Re: M/035/002  
Response to Division Letter March 2, 2010  
Deficient Submittal – Bingham Sediment Pond Drawing

Subject: Deficient Submittal – Bingham Sediment Pond Drawing, Kennecott Utah Copper, Bingham Canyon Mine, M/035/002, Salt Lake County, Utah

The Division has reviewed the Bingham Creek Sediment Pond Drawing received on December 21, 2009, and the following items will need to be addressed before the submittal can be determined complete:

FIGURE 2  
KENNECOTT UTAH COPPER CORPORATION  
BINGHAM SEDIMENT PONDS  
SCENARIO 3

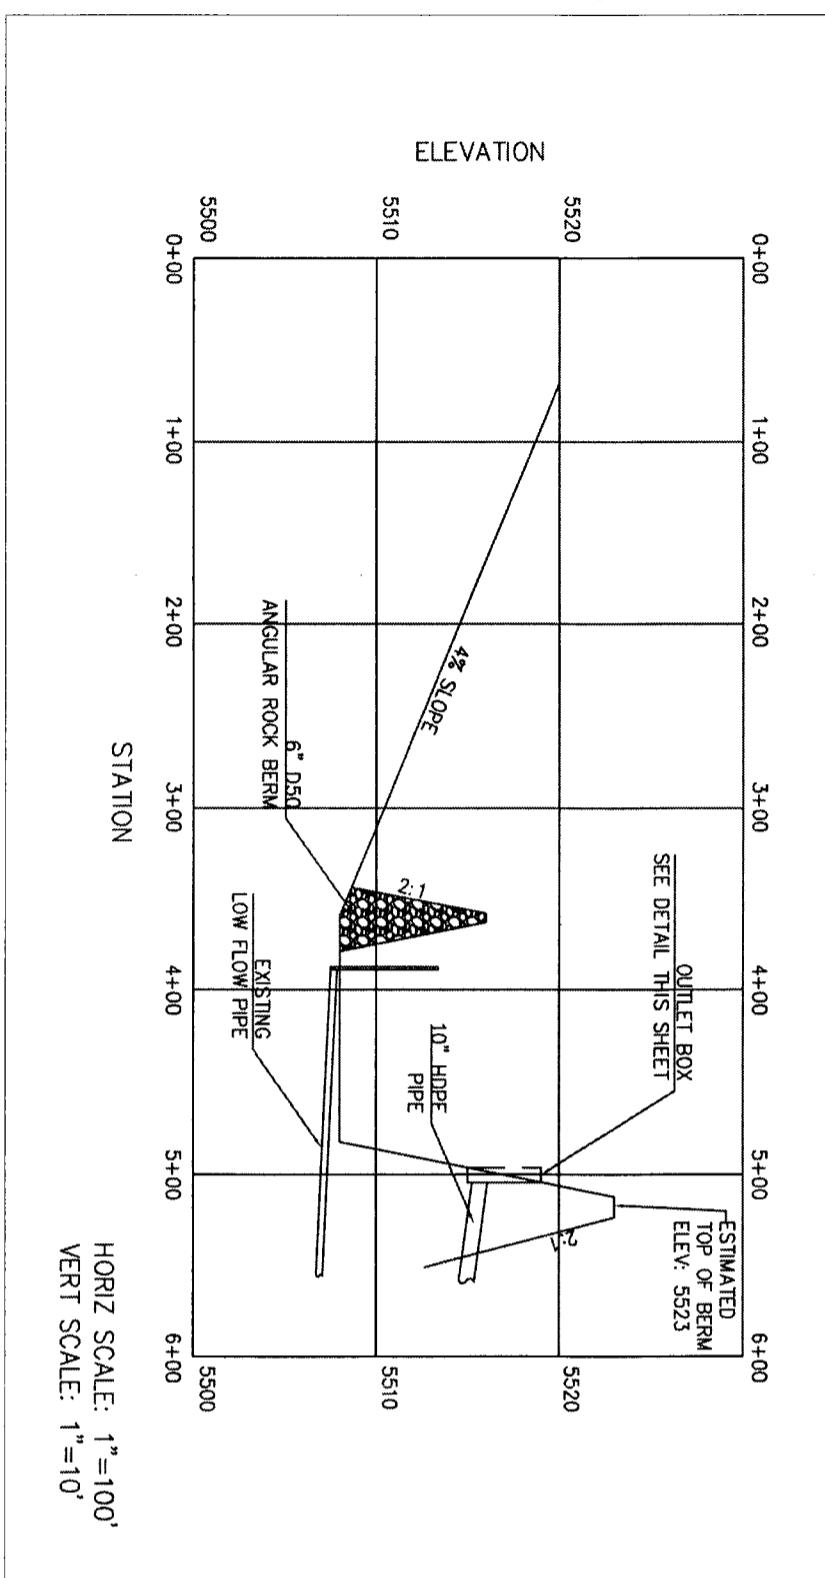
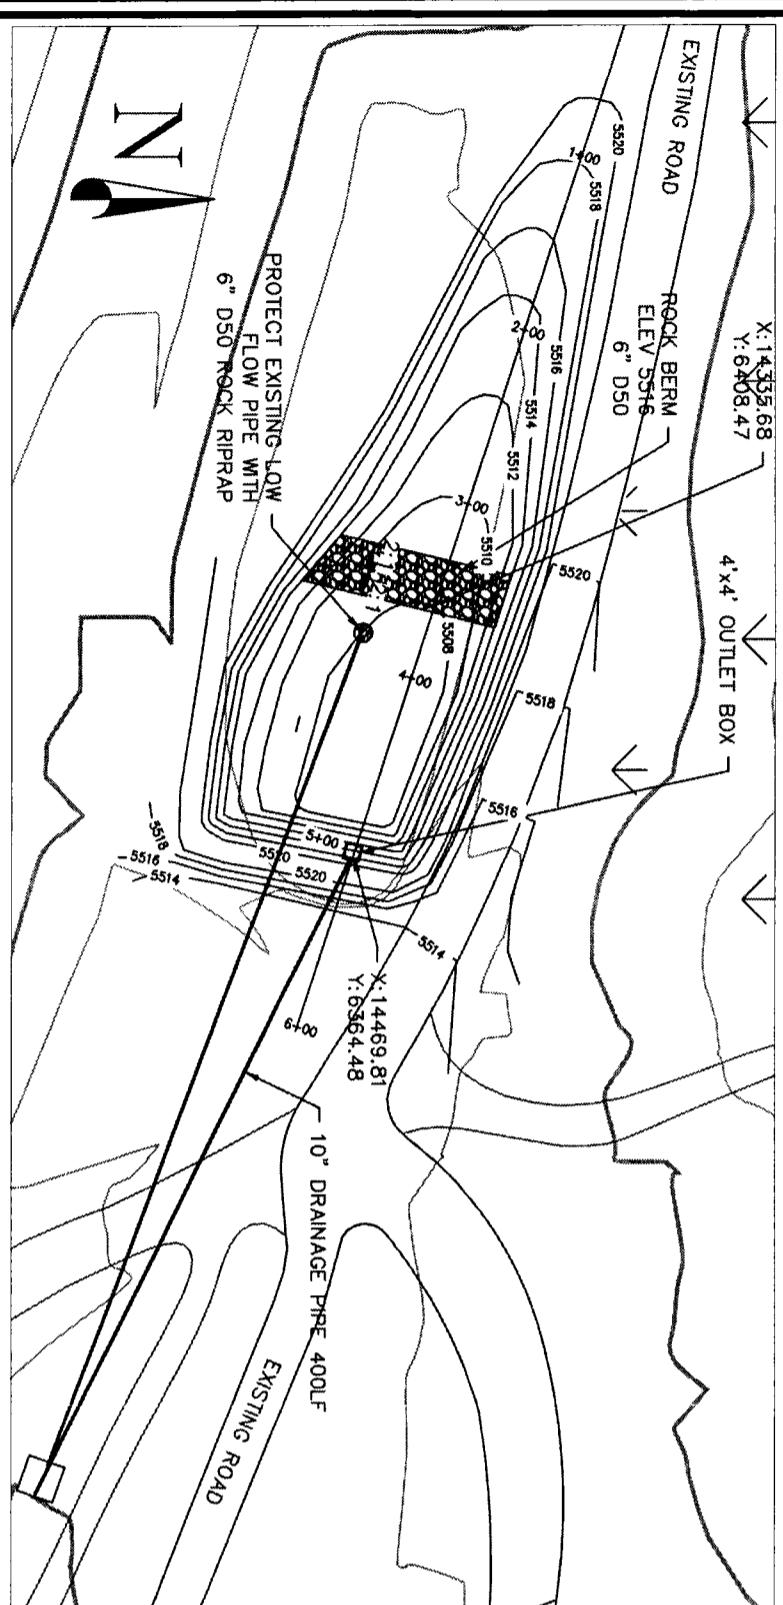
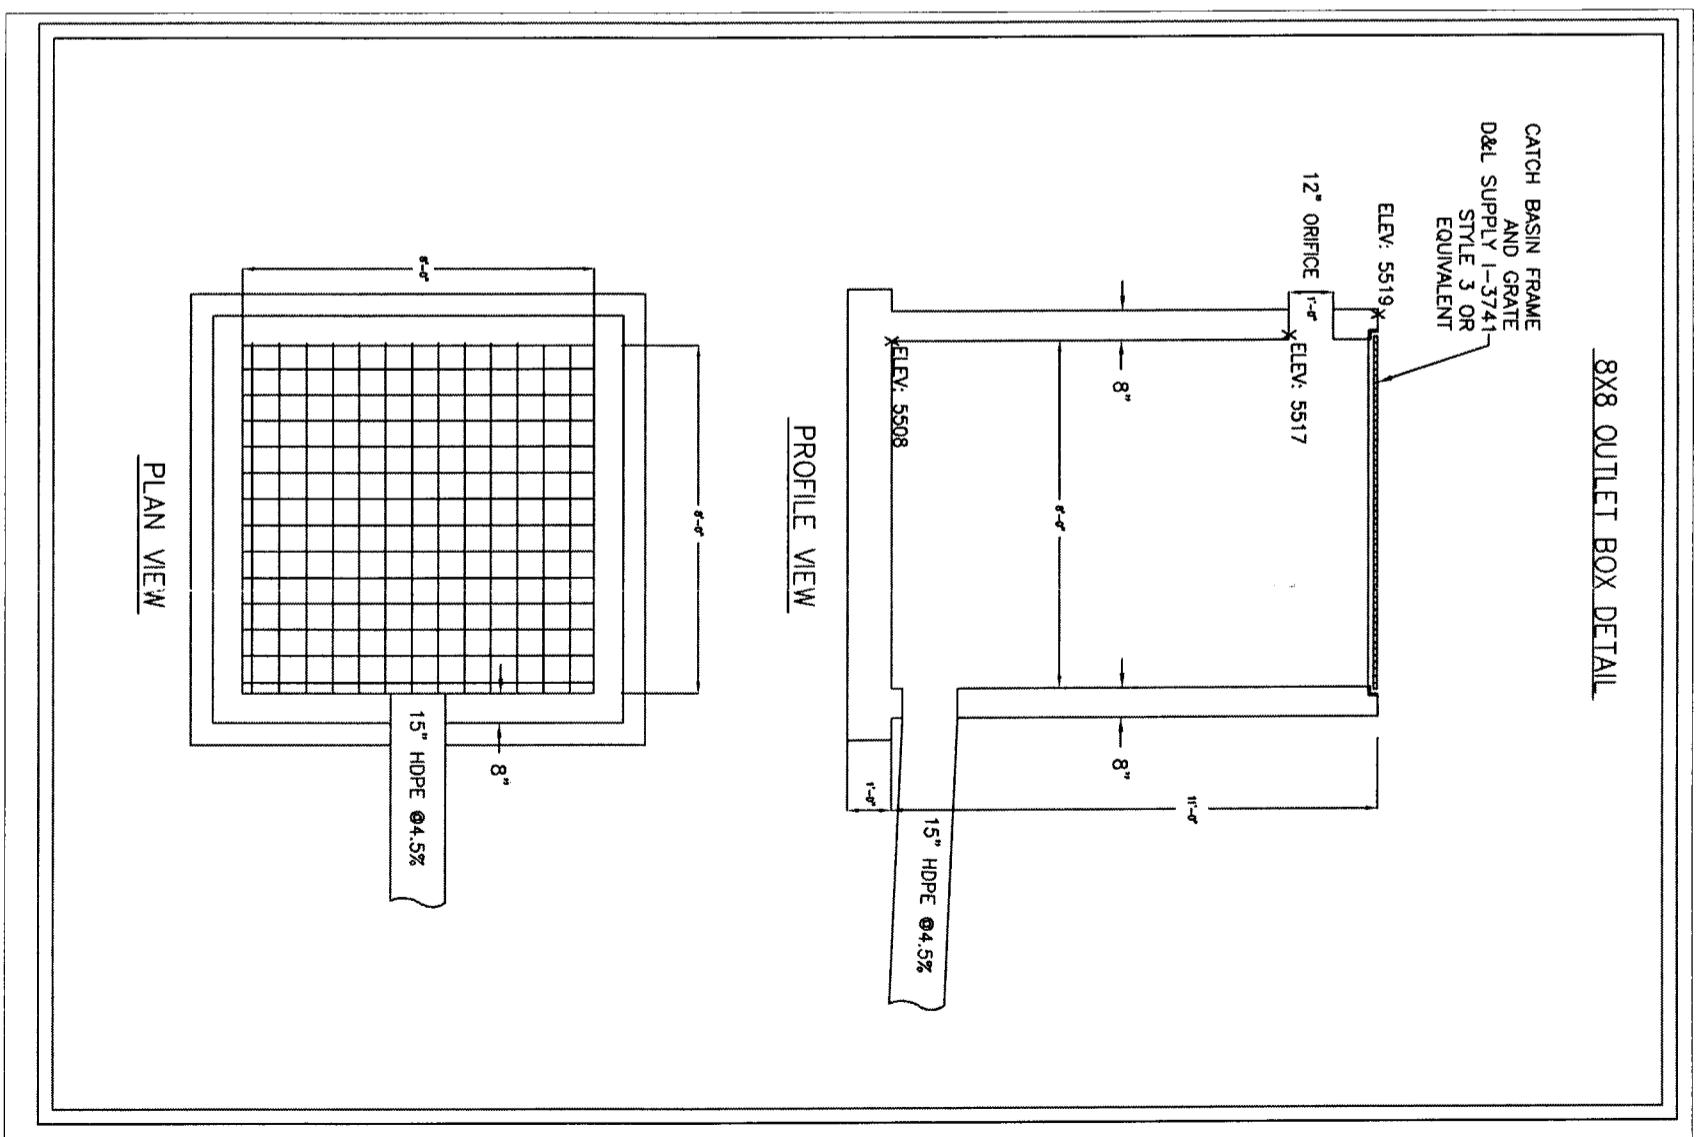
1. Figure 4, Upper left drawing – Include scale on the upper left drawing, and not on the title bar for the sheet. (lah)
2. Figure 4, Include a map showing the location of the upper left figure in relationship to Bingham Pit (lah)
3. It is unclear which figure 4 is to be replaced. (lah)
4. Submit Design Storm Calculations. This should include the ability of structures (i.e. spillways, low flow pipes etc) to safely pass the design event. Also, describe how structure will be reclaimed. Include the post-reclamation elevations and configuration of the area around the impoundment. If the structures are to be left as part of the post mining land use, then describe how they will be free draining and stable and how natural drainage patterns will be restored. Please provide an agreement with the land owner or land managing agency if these structures are to remain. (TM)

The submitted Figure 4 was a URS Corporation figure and not KUC figure.  
Changes are not warranted.

The submitted Figure 4 was a URS Corporation figure and not KUC figure.  
Changes are not warranted.

The submitted Figure 4 was from a URS report to KUC. It was provided to the Division as an informational item per Mr. Munson's request during the annual UDOGM / KUC Administrative Issues Meeting completed December 8, 2009.
